E2790
West Road Culvert Replacement and Related Work
Clarksburg, Massachusetts

ADDENDUM #2
September 25, 2026

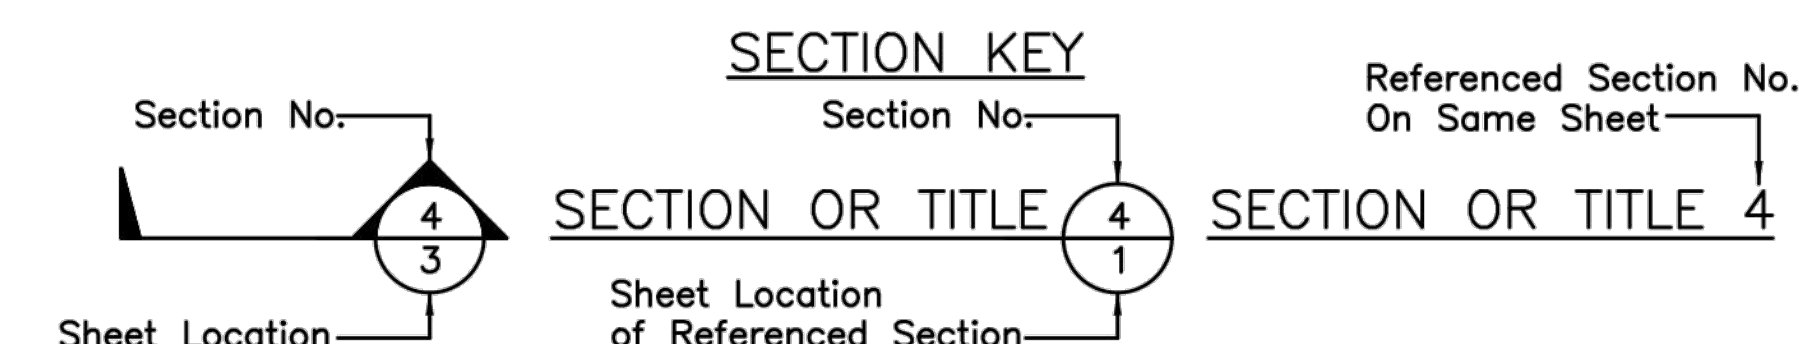
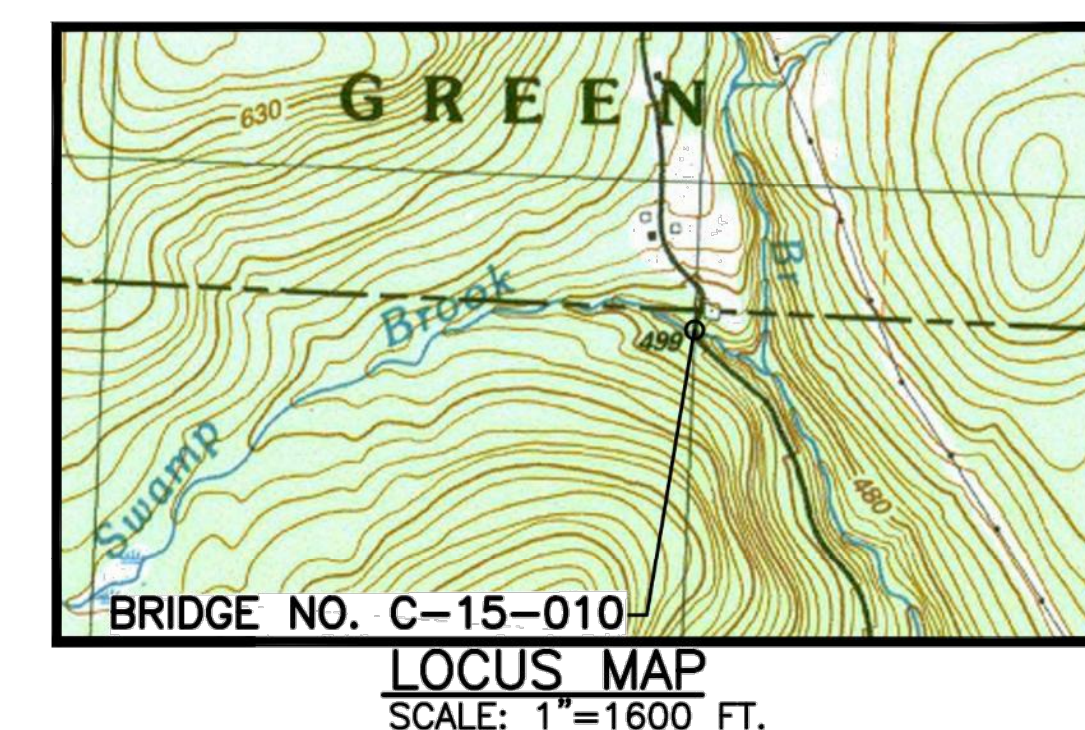
6. *Question: NOTE 1.0 on Drawing Sheet 1 of 9 states Bid Item for Bridge Structure Shall Include all labor, materials for the estimated removal and excavation of up to 35CY of Class B Rock Excavation along the base of all rigid frame and wingwalls footing founded on bedrock – See Sheets 3 & 4. Sheet 3 includes boring information. Sheet 4 is a general plan and cross section. The bid form includes 150CY of Class B Rock Excavation Item 4. Are the bidders to carry 150CY of Class B Rock Excavation under item 4 AND 35CY under item 14 (Bid Item for Bridge Structure)?*

Answer: Yes, please carry 150 CY under Item 4 and 35 CY under Item 14.
